FINAL
Environmental Impact Report
The Ranch Project
City of Antioch, Contra Costa County, California
State Clearinghouse Number 2019060012

Date: July 17, 2020

SECTION 1: INTRODUCTION

Figure 1: Location of Zeka Group Project Site

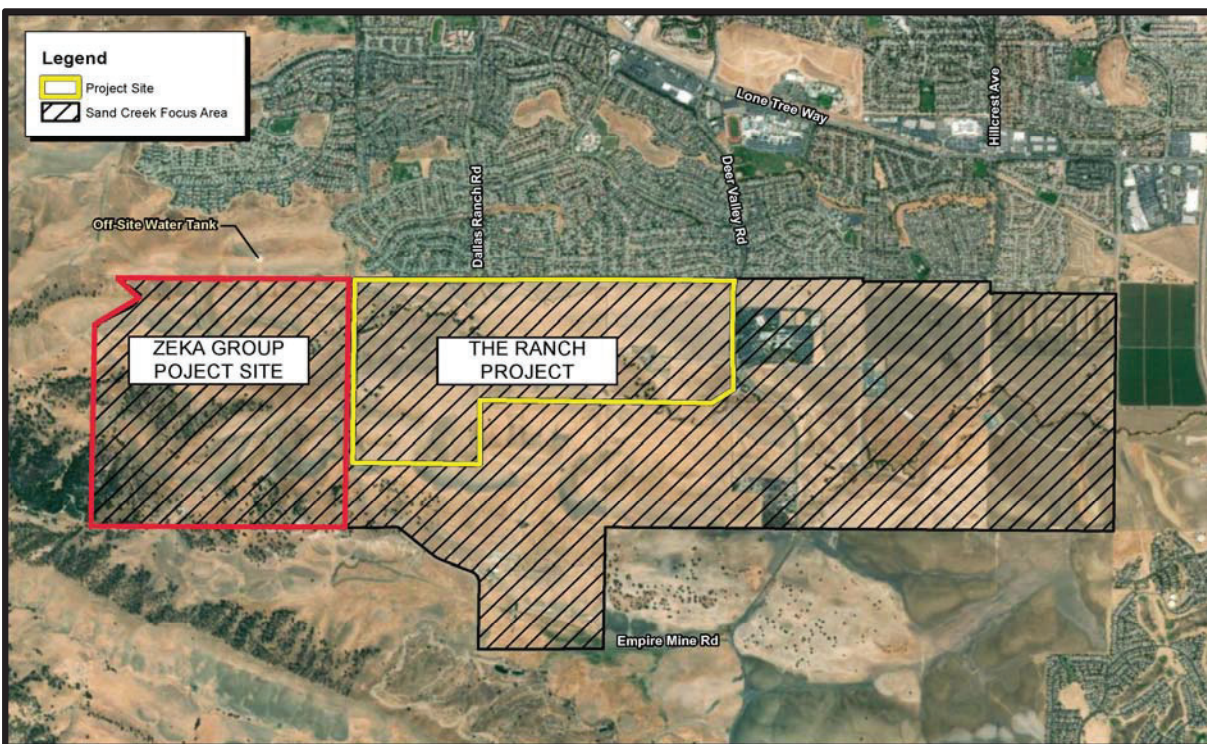
The complete omission of information about the Zeka Group's project frustrates the EIR's ability to accurately disclose and analyze cumulative environmental impacts. Furthermore, because the new residential housing units at the Zeka Project will be considered sensitive receptors for certain impacts (e.g. air quality, noise; see Draft EIR at p. 3.3-15 [discussing the definition of sensitive receptors]), the EIR fails to disclose and mitigate the full extent and severity of the Project's environmental impacts. At the very least, now that the City has been made aware of the existence of the Zeka Group's project, the EIR should be revised and recirculated to address this significant new information. (See Guidelines § 15088.5, subds. (a) & (b).)

The comments relating to Impact HAZ-6 and emergency evacuation plans are similarly unsubstantiated. For one, as noted above, no development currently exists on the Zeka property, but perhaps more importantly, The Ranch Project does not propose emergency access through the Zeka site at any point. Thus, no analysis relating to the Zeka site is required. Furthermore, contrary to the commenter's contention that "the EIR fails to provide any details about the specific location of emergency ingress and egress points, Exhibit 2-13, entitled Emergency Vehicle Access, clearly details these points of access. (The reference to Exhibit 2-14 on the bottom of Draft EIR page 3.8-32 is a typographical error, which has been corrected in the Final EIR Errata). As to a concern that the proposed Emergency Vehicle Access (EVA) have not been sufficiently studied or analyzed, the City notes that Exhibit 2-13 has been reviewed and discussed in detail with the Contra Costa Fire Department, and the Department has indicated no concerns regarding the proposed EVAs.

Exhibit 3.4-10 Trail Impacts

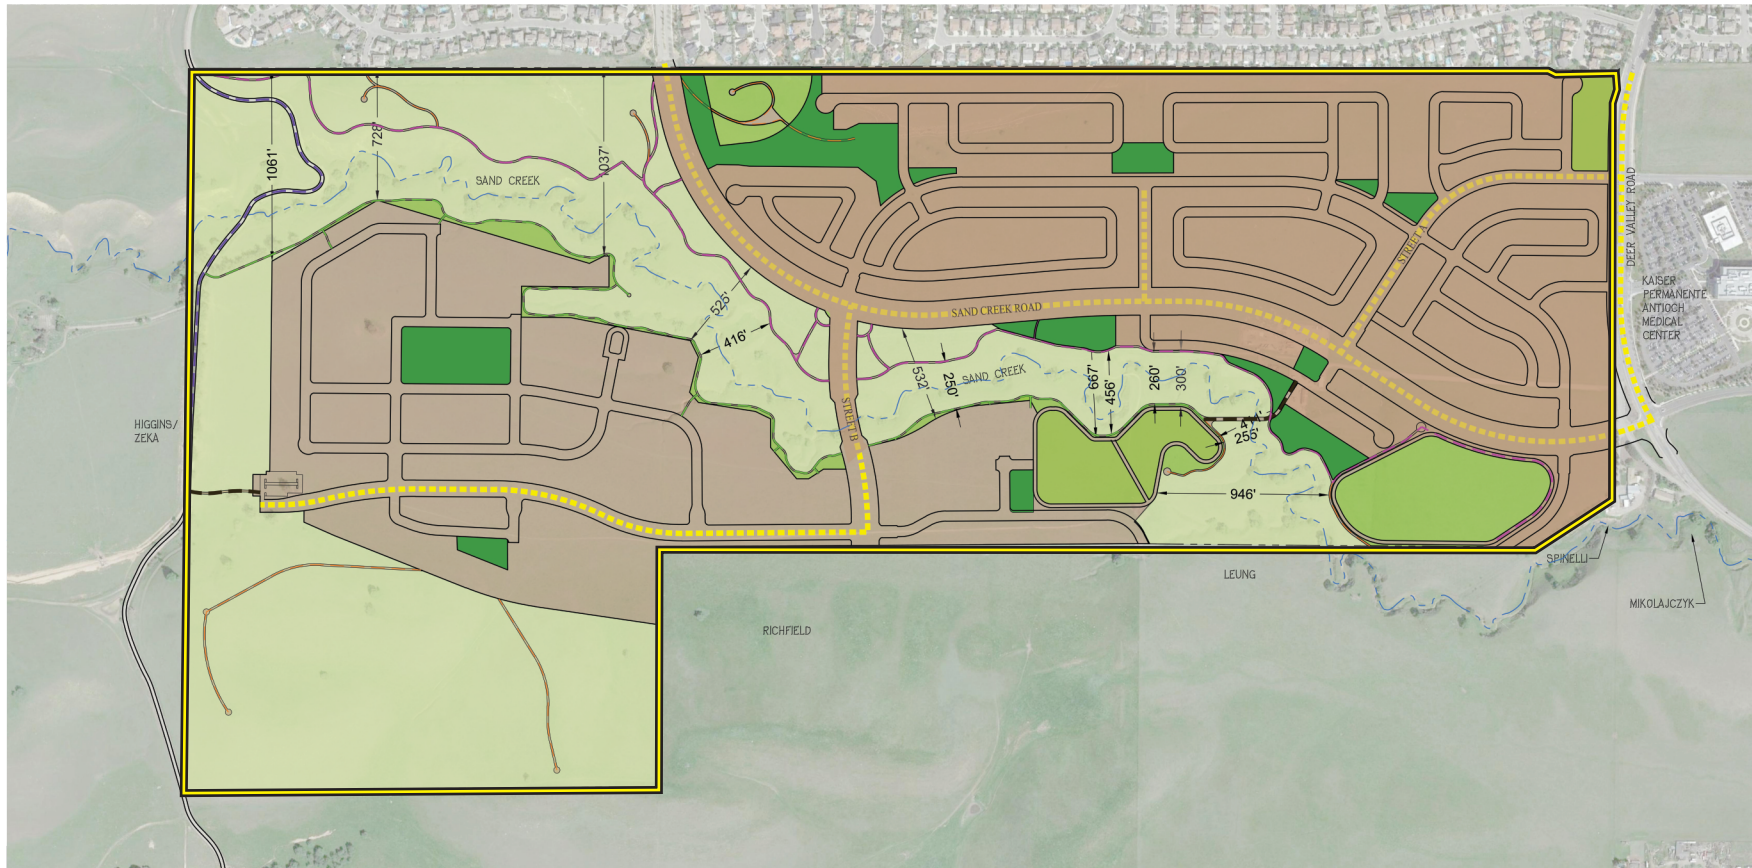
3. The DEIR’s On-Site Parks and Open Space map (Exhibit 2-10) indicates that recreational trails could be built though or immediately adjacent to Special Status plants and Sensitive Natural Communities, such as the California Goldfields—Dwarf Plantain—Small Fescue Flower Fields. Please analyze and avoid, or otherwise mitigate, for trail construction impacts to Special Status plants and Sensitive Natural Communities.

The CNPS states that Exhibit 2-10 (On-site Parks and Open Space Map) indicates that trails could be built through or adjacent to special-status plants and sensitive natural communities, and asks that the City analyze and avoid or mitigate for construction impacts. Impact BIO-1 analyzes construction and operation impacts to special-status plants and wildlife. (See Response to Comment EBCNPS-4 above).
